3 H@NC - 60 Eagle Crest Court, Lillington, NC 27546

The Holly - LH 'CRAFTSMAN' ELEVATION

9-26-24 - Redlines - JJ

9-27-24 - Remove Gourmet Kitchen - JJ

SLAB FOUNDATION PLAN 'CRAFTSMAN'
SCALE: 1/8"=1'-0" ON 11x17, 1/4"=1'-0" ON 22x34

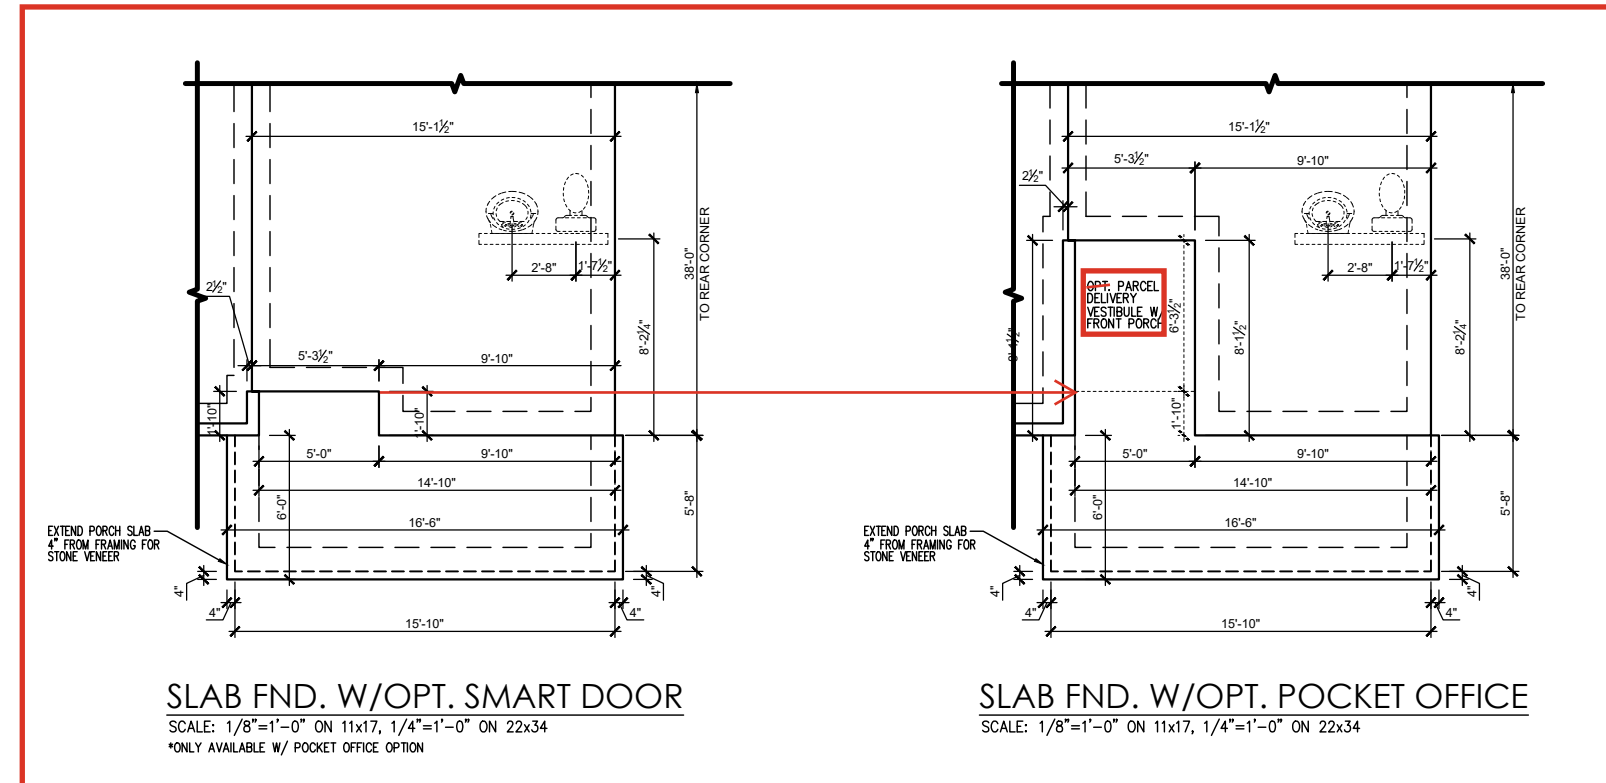
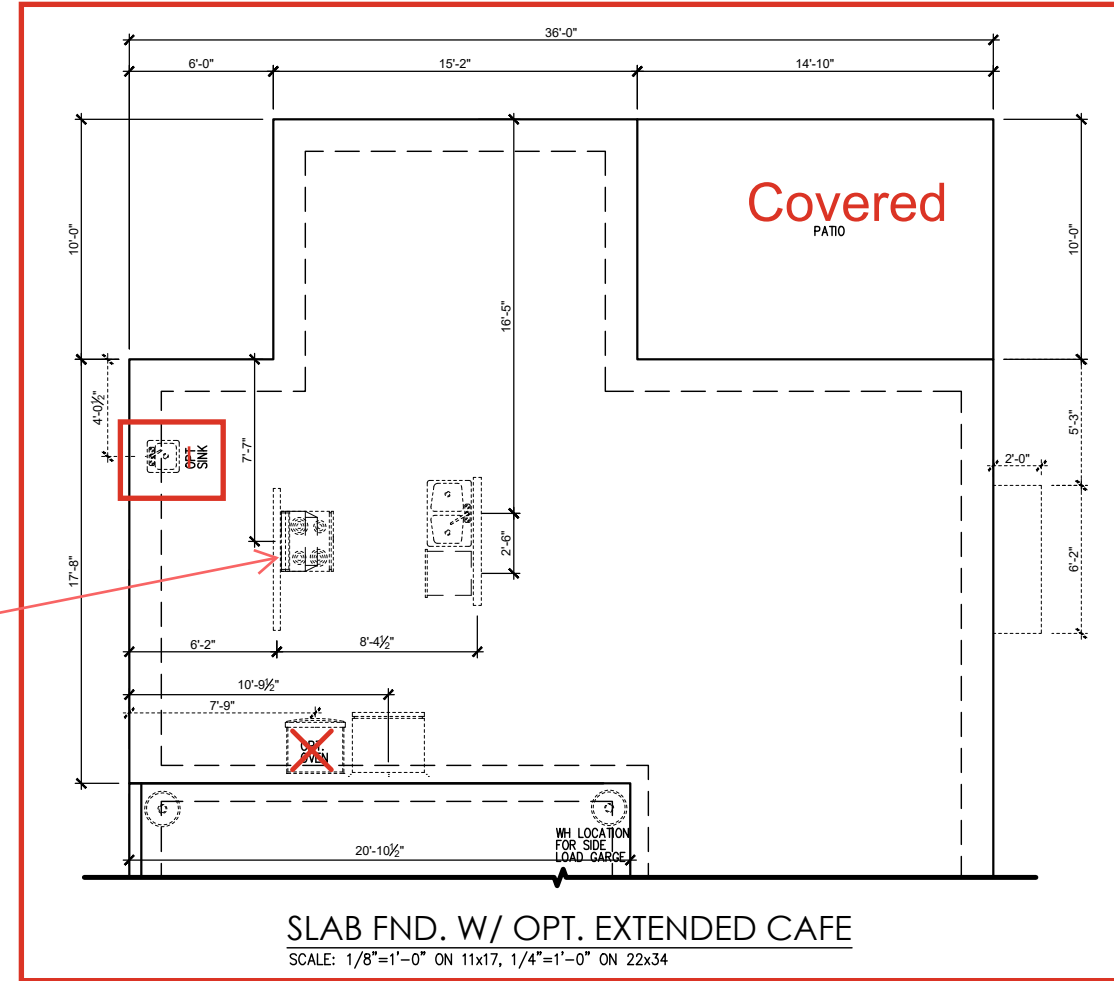
1.1.1a for cov. porch, cafe, kitchen and garage

53'-8" Overall + 4" front porch slab extension for column as noted

5'-8" porch dim + 4" slab ext for column as noted

1.1.1a for smart door delivery, pocket office and porch

53'-8" overall dim + 4" porch slab extension for column as noted
38'-0" dim

Sheet 2.1.1a for cafe and covered porch, kitchen, messy kitchen, pantry & drop zone

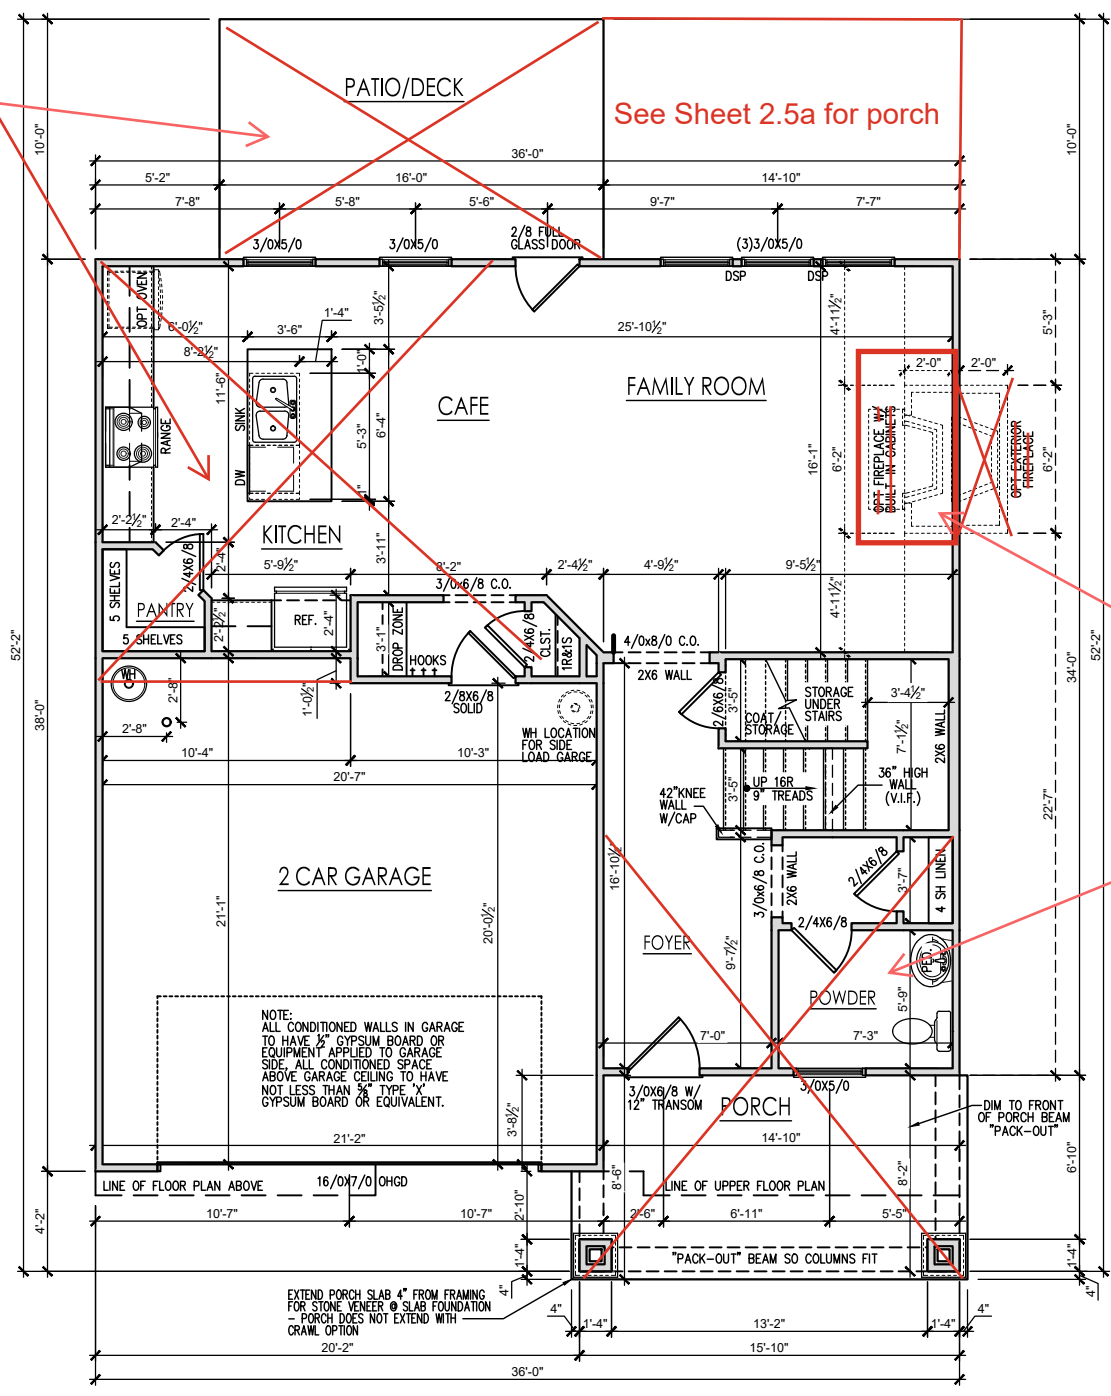
See Sheet 2.5a for porch

2.1.1a for interior fireplace

2.1.1a for pocket office, smart door delivery and porch

SECOND FLOOR PLAN 'CRAFTSMAN'

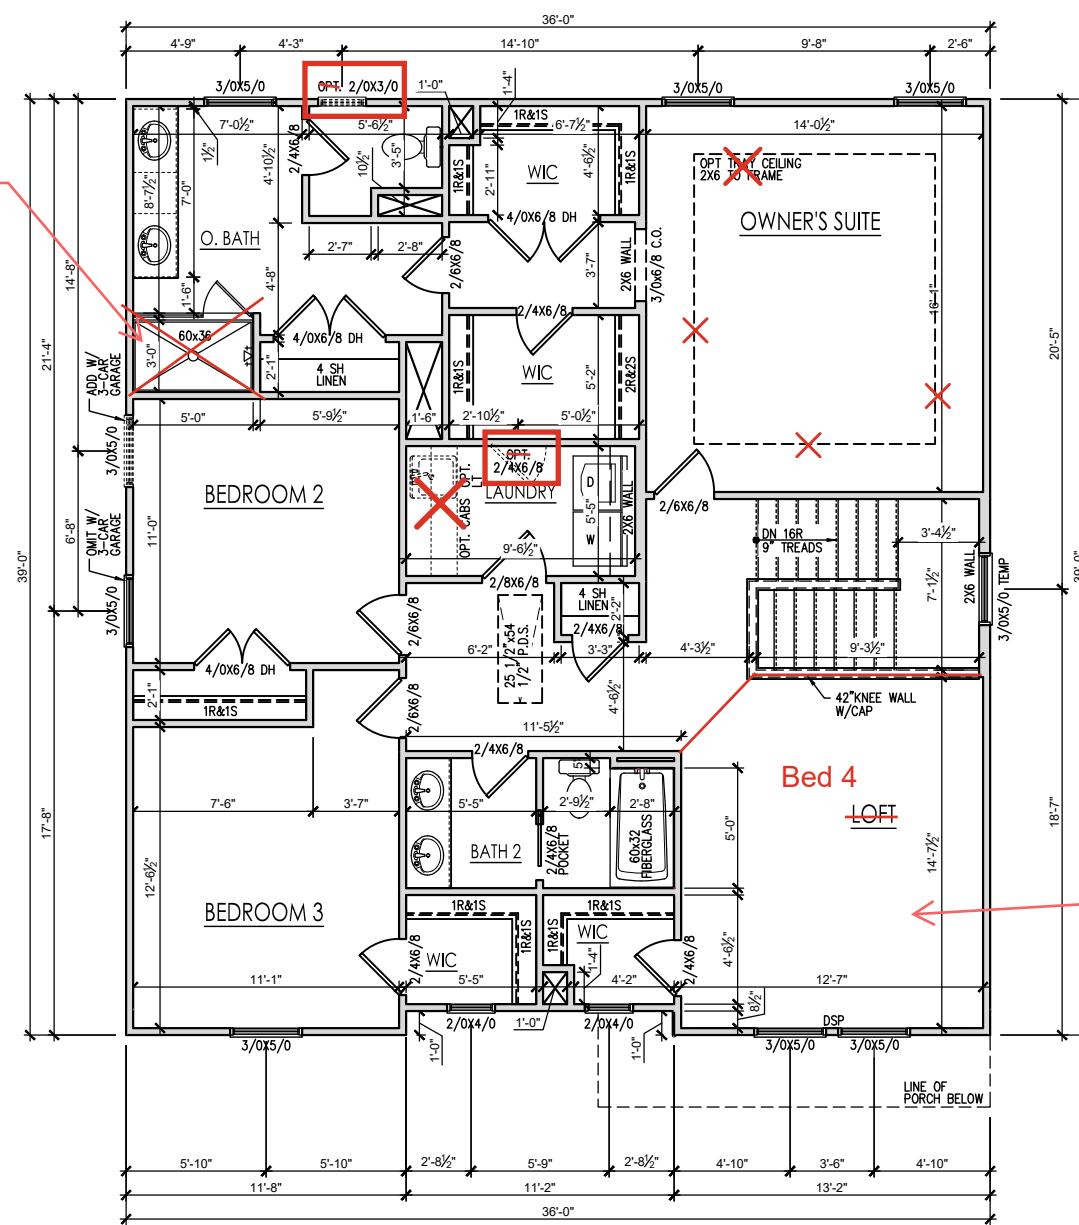
2.2.1a for shower with seat

2.2.1a for Bedroom 4

LEFT SIDE ELEVATION 'CRAFTSMAN' (SLAB)
SCALE: 1/4" = 1'-0" ON 22x34, 1/8" = 1'-0" ON 11x17

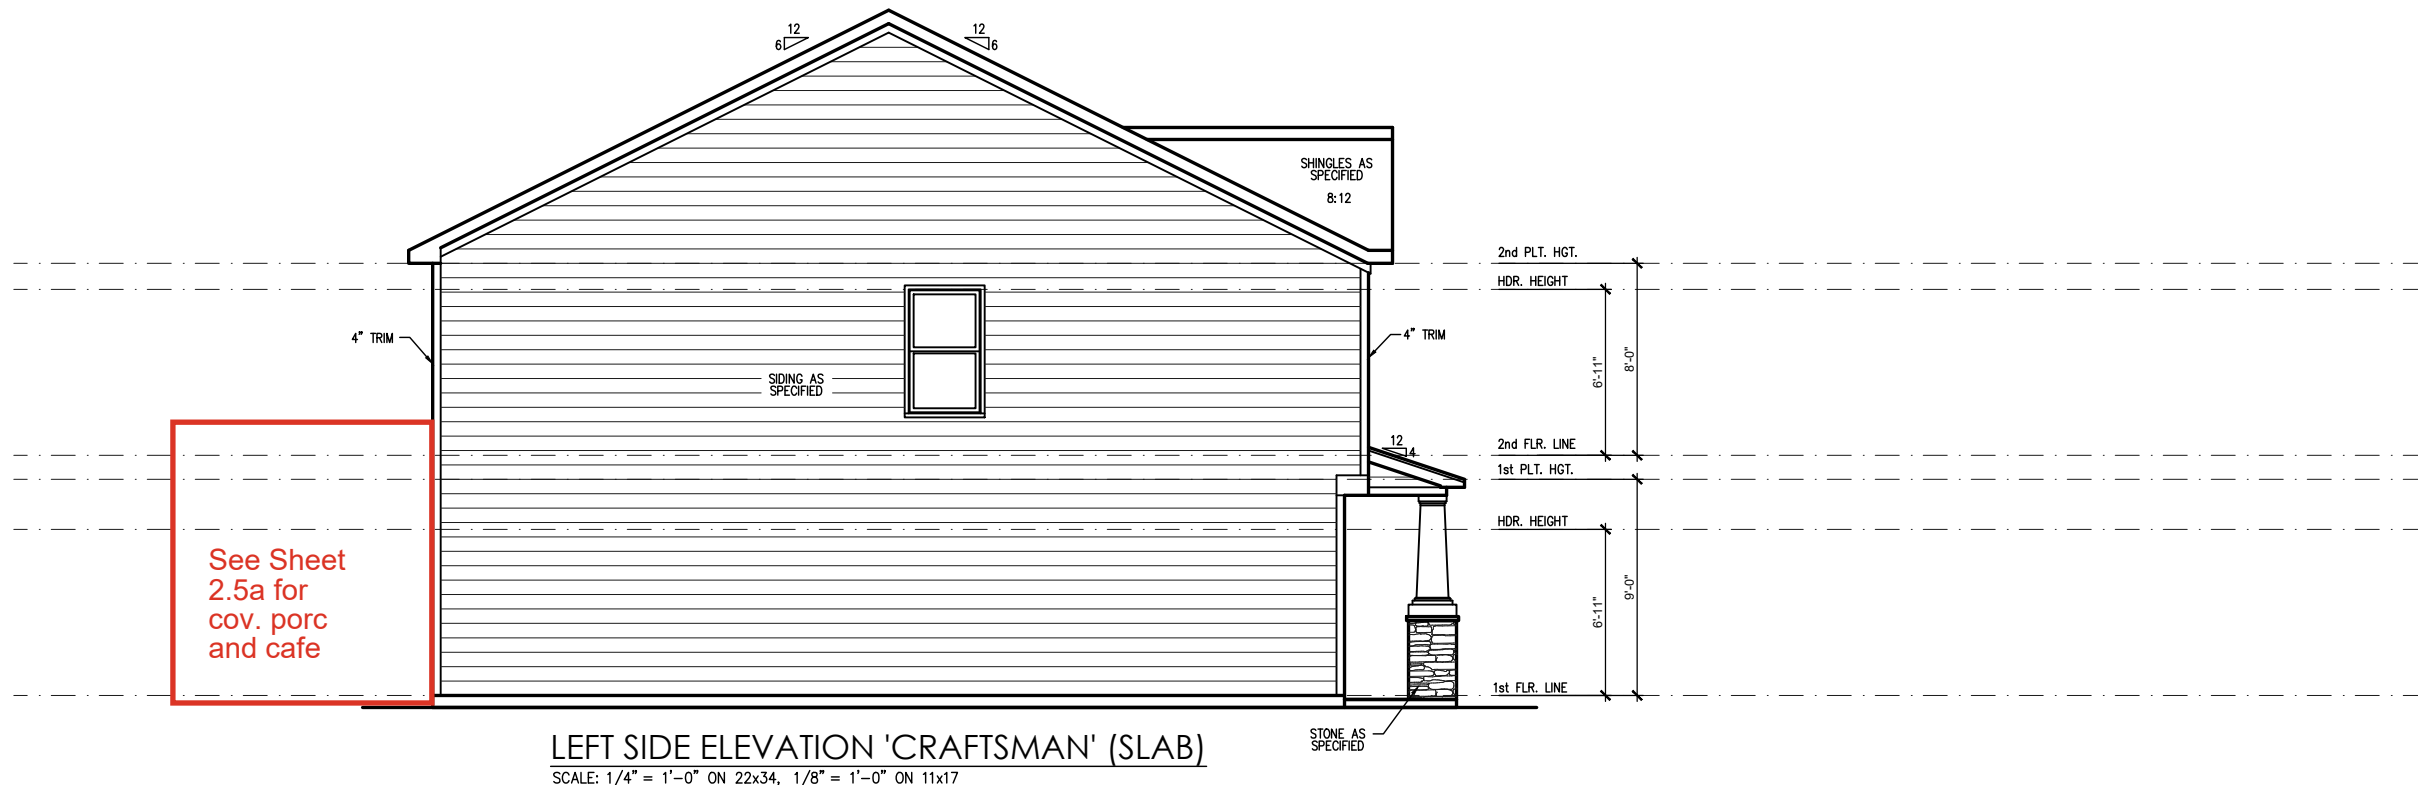
See sheet 2.5a for cafe and cov. porch

CRAFTSMAN ROOF PLAN
 SCALE: 1/4" = 1'-0" ON 22x34, 1/8" = 1'-0" ON 11x17

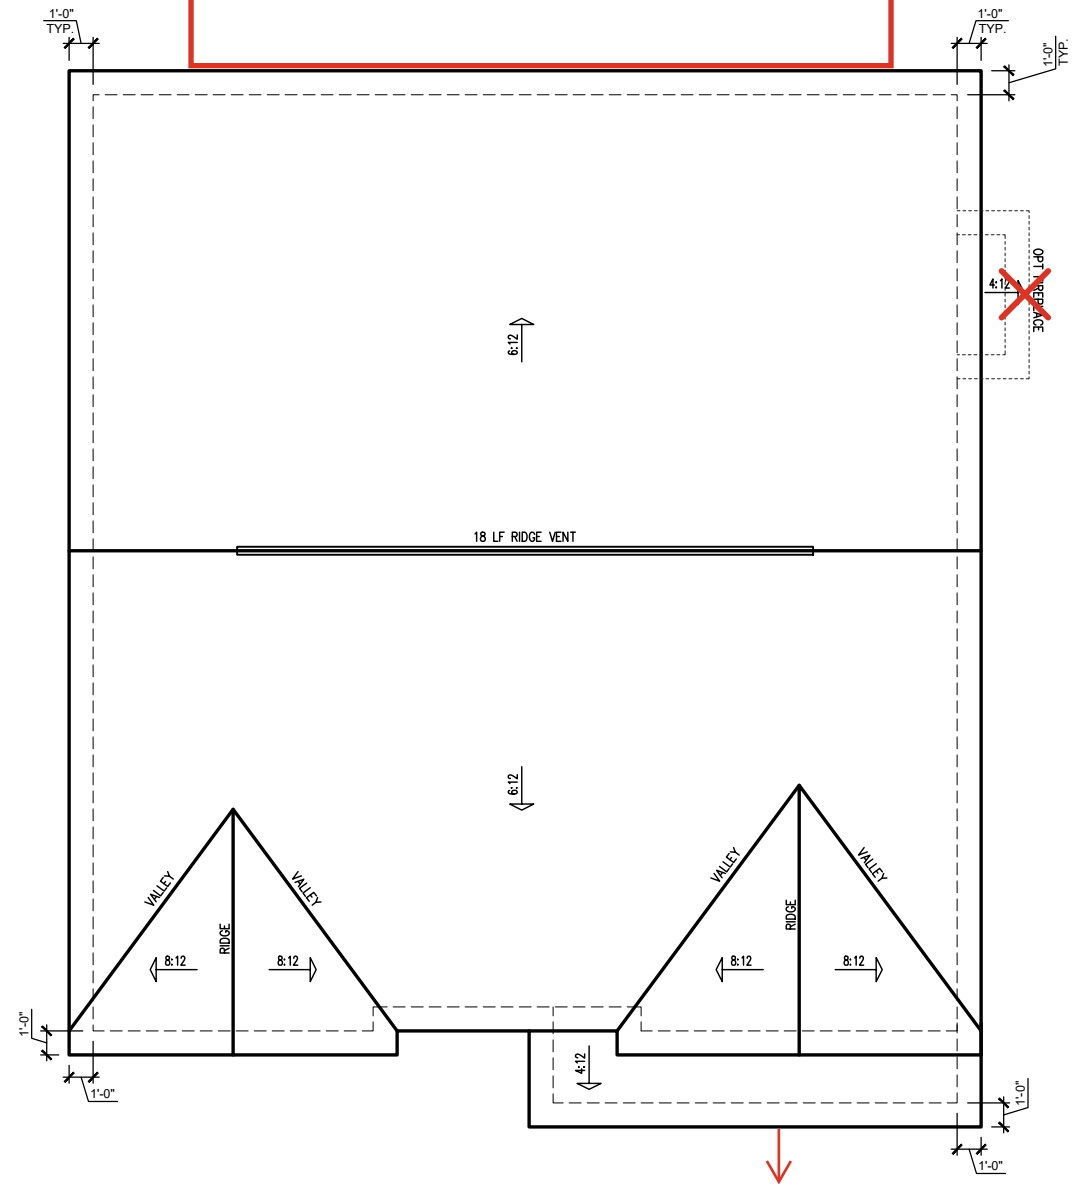
See sheet 2.5a

SLAB FOUNDATION PLAN 'CRAFTSMAN'
SCALE: 1/8"=1'-0" ON 11x17, 1/4"=1'-0" ON 22x34

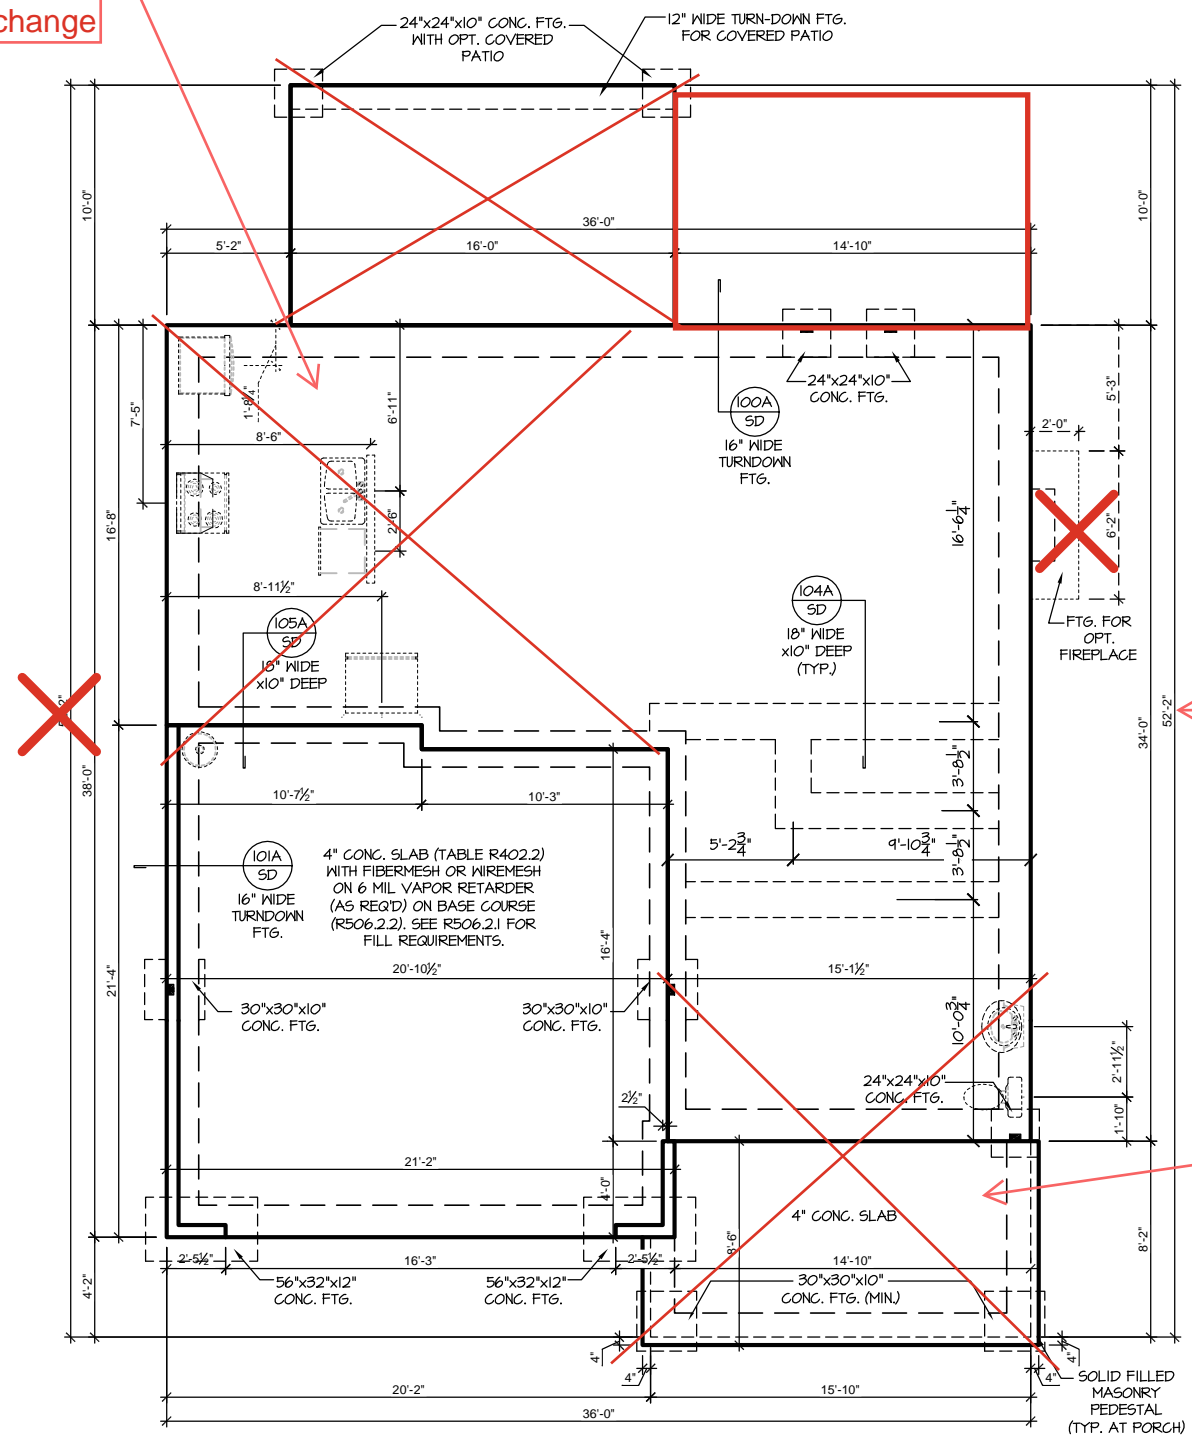
S-1.1.1 for cafe and cov. porch, garage wall change

53'-8" Overall + 4" front porch slab extension for column as noted

S-1.1.1 for pocket office, smart door delivery and porch
